TfNSW reference: REN25/00086/002

Your reference: SSD-72430958

**SSD-72430958, Finley Battery Energy Storage System - Various Lots, Berrigan Shire Council;
Response to Environmental Impact Statement**

Figure 1 – Affected median, intersection of the Newell and Riverina Highways.

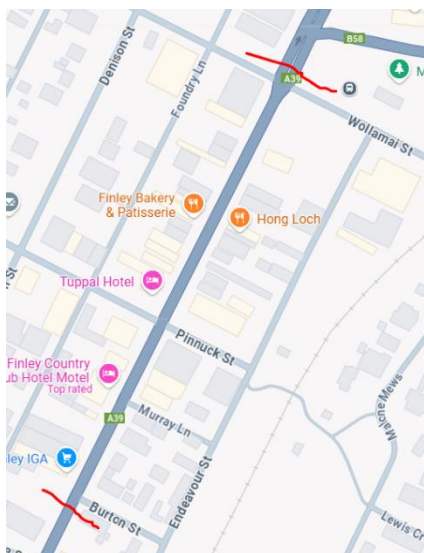
- v. The route study demonstrates that medians will be tracked over, including at the intersection of the Newell Highway and Riverina Highway. See figure 1 within **Attachment B**. The proponent is to investigate whether the high-risk OSOM can avoid tracking over any medians or other infrastructure on the state road network.

- vi. Strategic concept designs will be required for works required along the state road network (for example, the median identified in e) that identify the scope of the works that would be necessary to ensure the asset could be made suitable for traversing (i.e pavement strengthening) or temporary removal.
